Addendum to Arboricultural Report

21A Didsbury Park
Didsbury
Manchester
M20 5LH

Project No.:	UG11551			
Project:	21 Didsbury Park			
Location:	21A Didsbury Park, Didsbury, Manchester, M20 5LH			
Title:	Addendum to Arboricultural Report			
Document Type:	BS 5837			
Date:	27/10/2022			
Prepared By:	Adam Hodgins			
Checked By:	Martin King			
Approved By:	Martin King			
Revision Status:				
Rev:	Date:	Issue/Purpose/ Comment:	Prepared:	Checked:

This report and updated drawings are to be read as part of an addendum to the previous submitted Arboricultural Impact Assessment (AIA) report and included Arboricultural Method Statement (AMS) (ref: UG_1151_ARB_AIA_Rev_P09 2 (April 2019)) dated 27/10/2022.

Client:	EDMUNDS ARCHITECTS		
Project:	21 DIDSBURY PARK		
Title:	TREE REMOVAL PLAN		
Issue:	PLANNING		
Drawn:	AH	Checked:	MK
Project:	UG11511	Scale @ A1:	1:1000
Dwg No:	UG_11551_ARB_TRP_03	Approved:	MK
		Date:	28/10/22
		Revision:	00

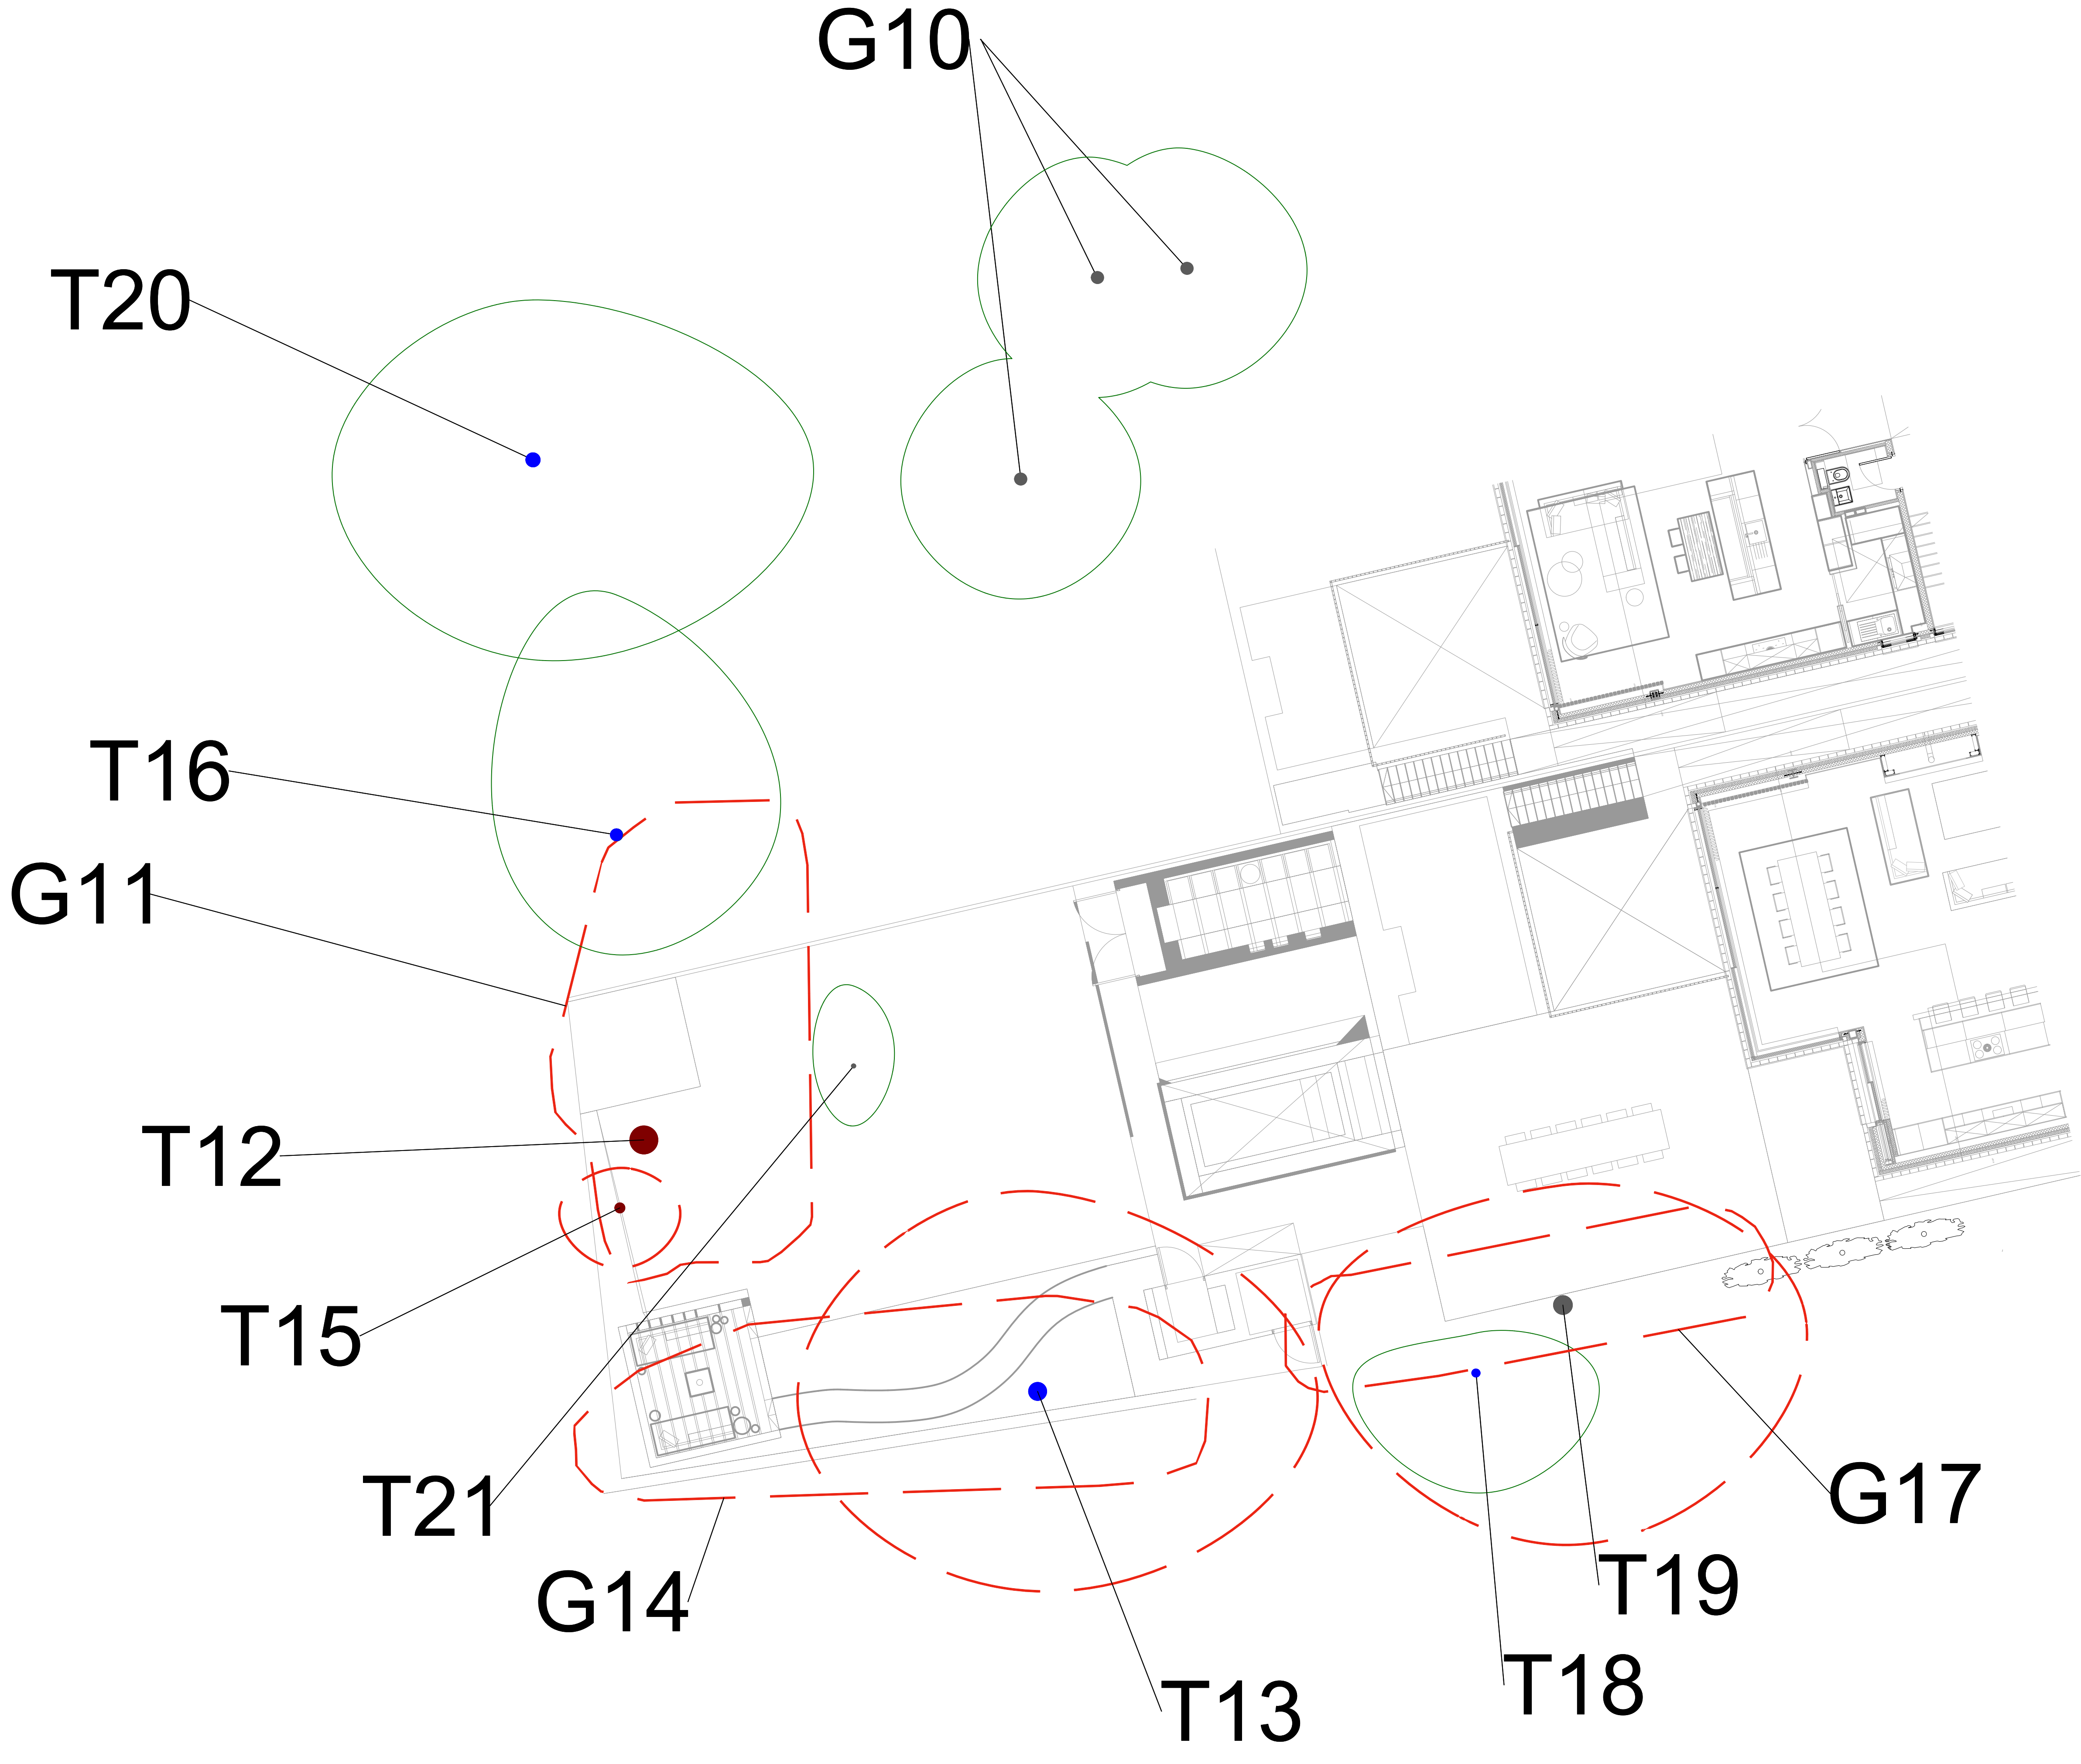
The additional proposed development requires the removal of two tree groups and one individual tree assessed as 'Moderate Quality' BS5837 Retention Category 'B'; and one tree group and one individual tree assessed as 'Low Quality' BS5837 Retention Category 'C', as detailed in the Tree Removal Plan at Appendix 1.

A further two individual trees assessed as 'Unsuitable' BS5837 Retention Category 'U' and have been recommended for removal irrespective of the additions to the proposed development, as shown on the Tree Removal Plan at Appendix 1.

Client: EDMUNDS ARCHITECTS		
Project: 21 DIDSBUY PARK		
Title: TREE PROTECTION PLAN		
Issue: PLANNING		
Drawn: AH	Checked: MK	Approved: MK
Project: UG11551	Scale @ A1: 1:1000	Date: 28/10/22
Dwg No: UG_11551_ARB_TPP_03	Revision: 00

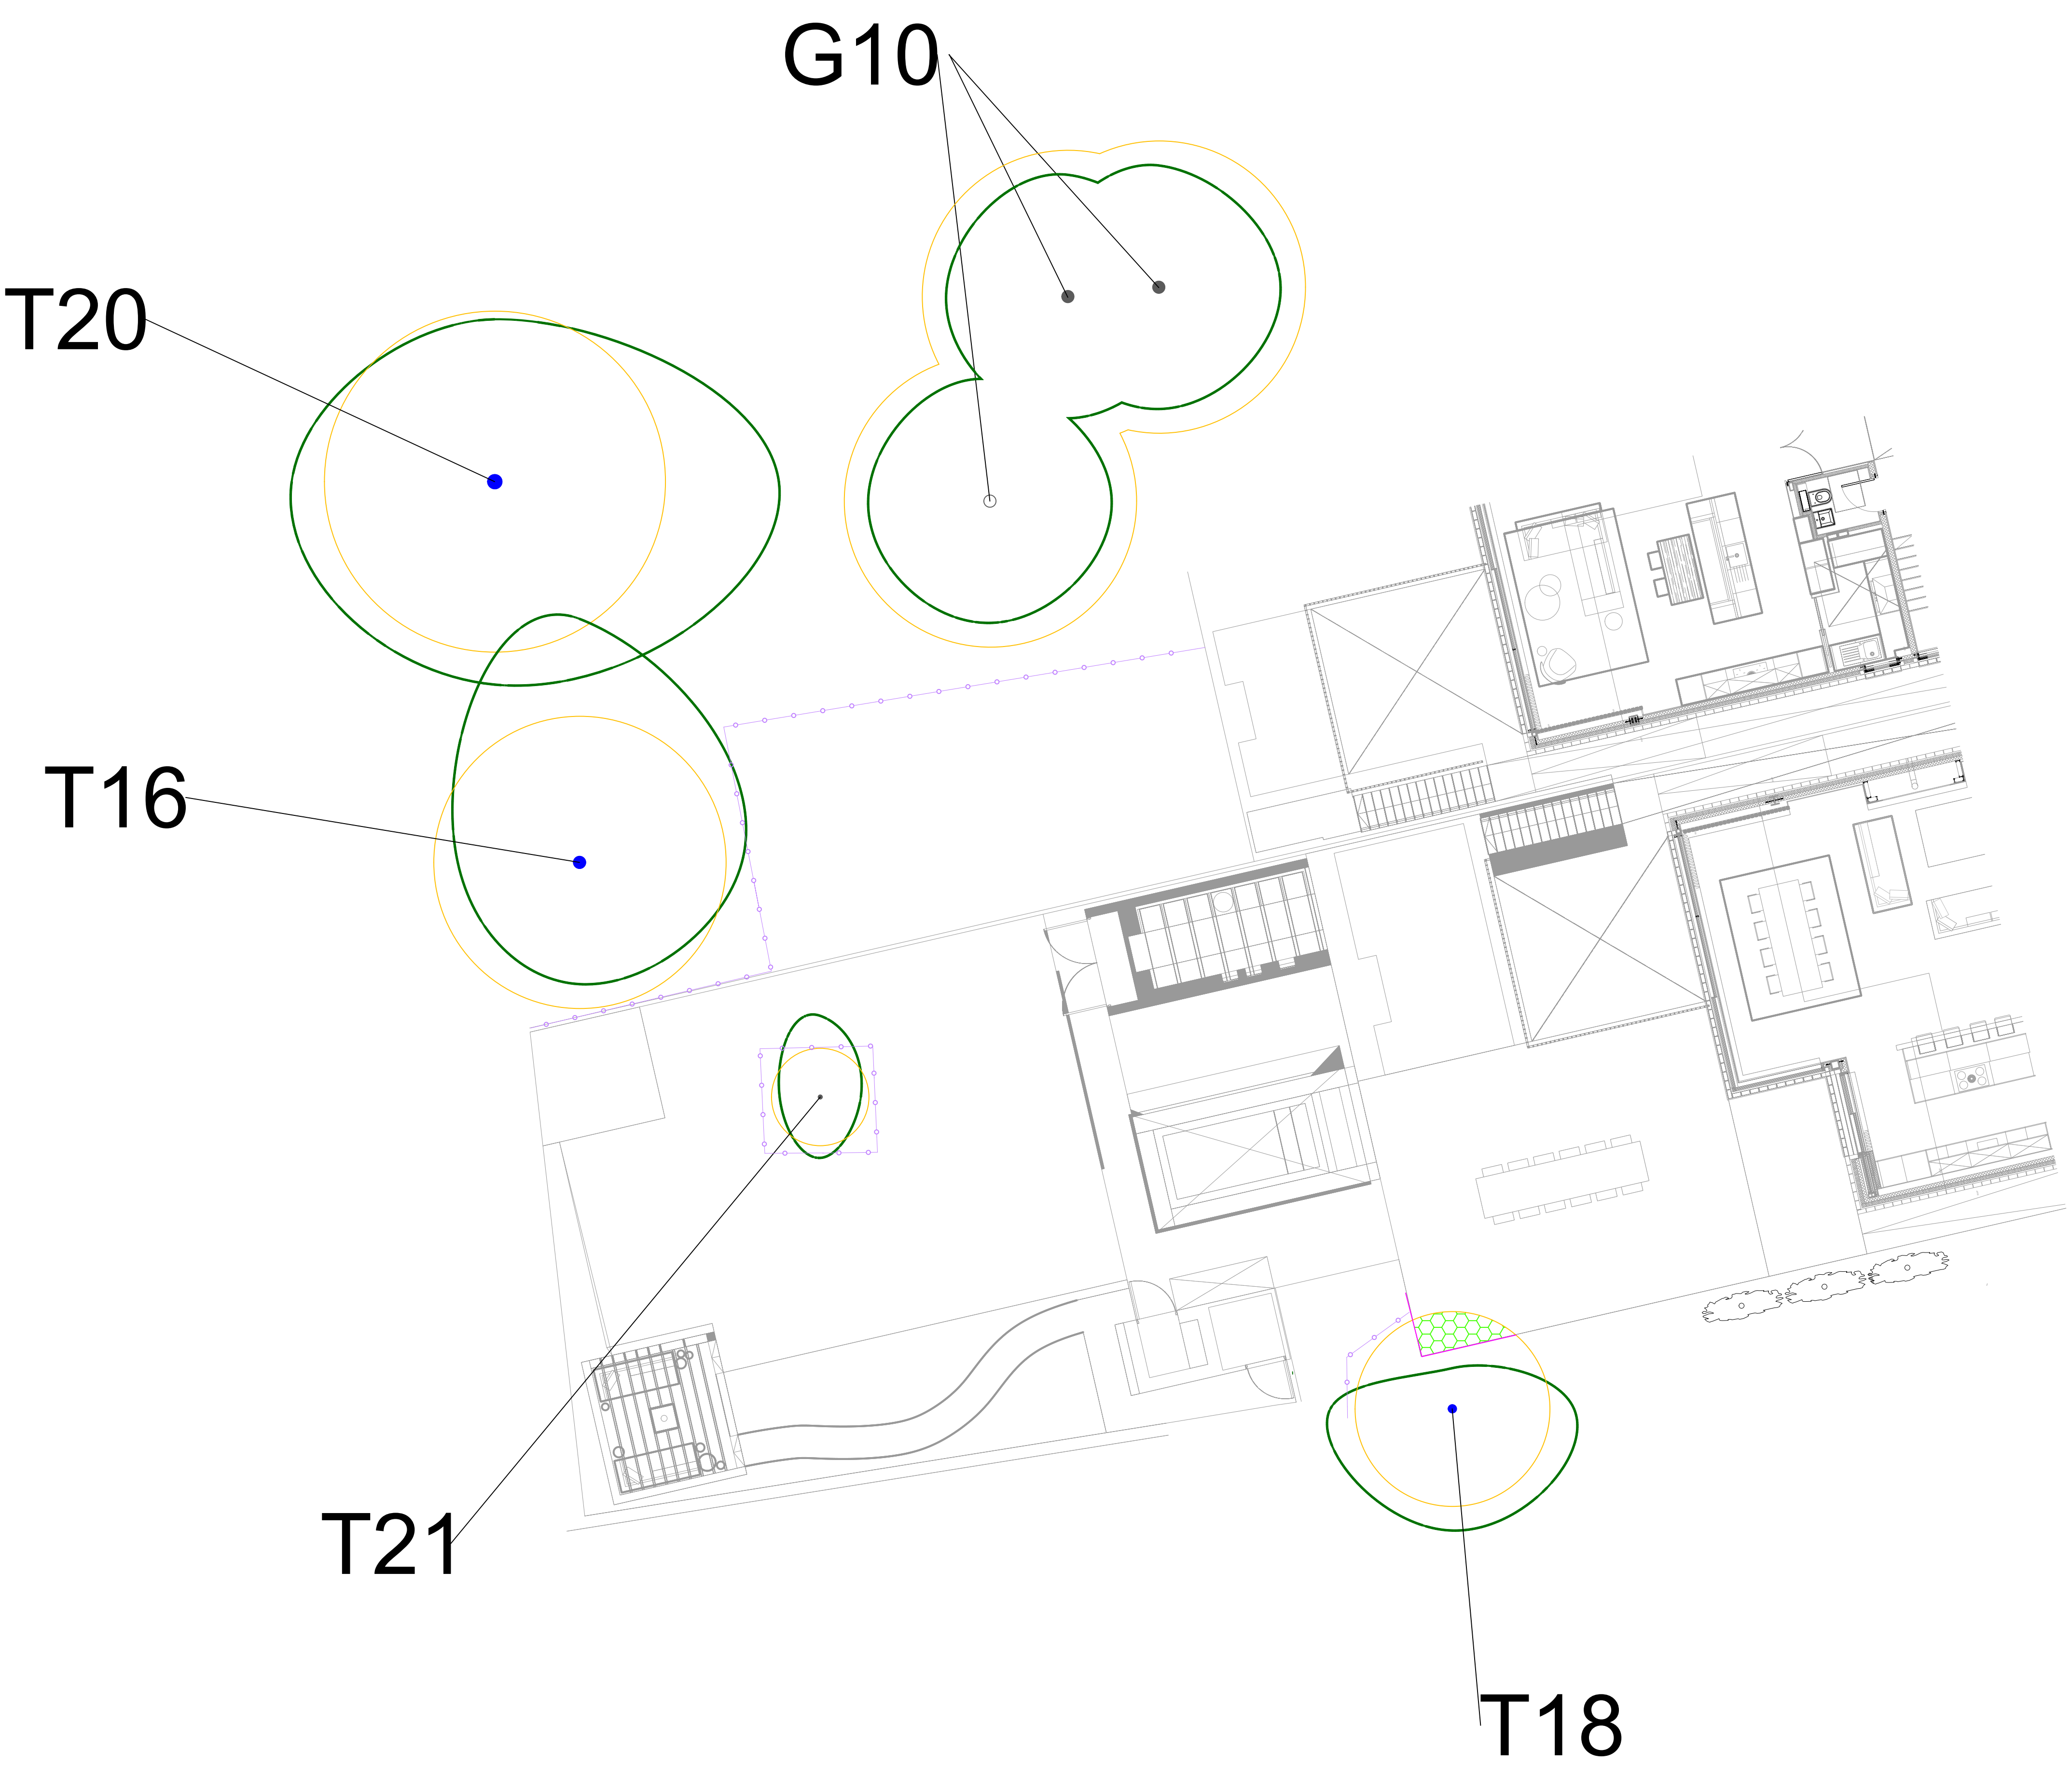
Temporary protective fencing will need to be installed around the predicted RPAs of retained trees G10, T16, T18, T20 & T21 in line with the specification in the AIA report at the position shown on the Tree Protection Plan at Appendix 2.

Supervised root pruning will be required within the predicted RPA of T18 to avoid damage to significant tree roots, as detailed in the AIA report and the Tree Protection Plan at Appendix 2. Incursion into the portion of the RPA of T18 is within the twenty per cent threshold amount detailed in BS5837 and should not adversely affect the health or stability of T18.

A Cellular Confinement system will need to be used where the proposed structure encroaches the predicted RPA of T18, in accordance with the AMS provided in the AIA report, at the location in the Tree Protection Plan at Appendix 2.
